Groundwater Transfer Review Summary Form

Transfer/PA # T- 14653

Application: T-14653

Applicant Name: Kenneth and Kami Good

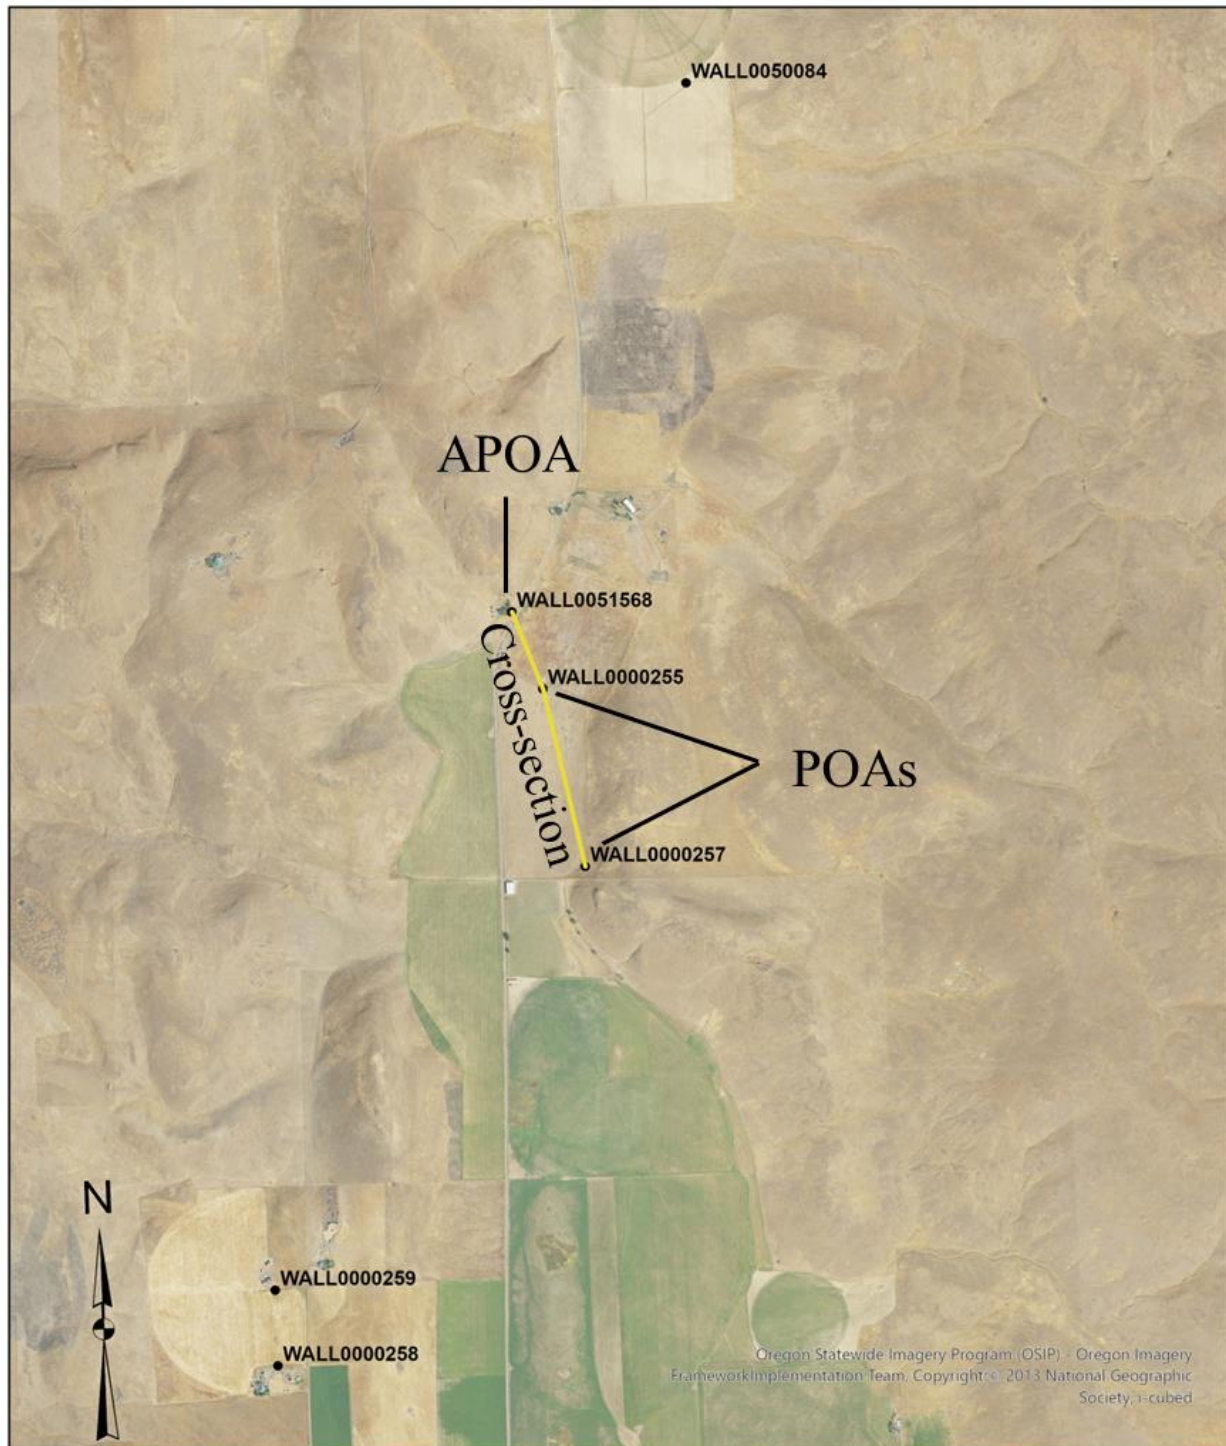
2. Will the proposed POA develop the same aquifer (source) as the existing authorized POA?
☒ Yes ☐ No Comments: Both authorized POA wells, WALL 255 and WALL 257, produce from horizons within the Columbia River Basalt Group (CRBG) sequence. The proposed POA, WALL 51568, also produces from these horizons and displays similar water level elevations (see attached hydrograph).

8. What conditions or other changes in the application are necessary to address any potential issues identified above: _____
9. Any additional comments: Currently authorized POA WALL 255 is a current State Observation Well (SOW) with an extended measurement record. Measurements exhibit modest declines over the period of record, being somewhat more severe in recent years (see attached hydrograph).
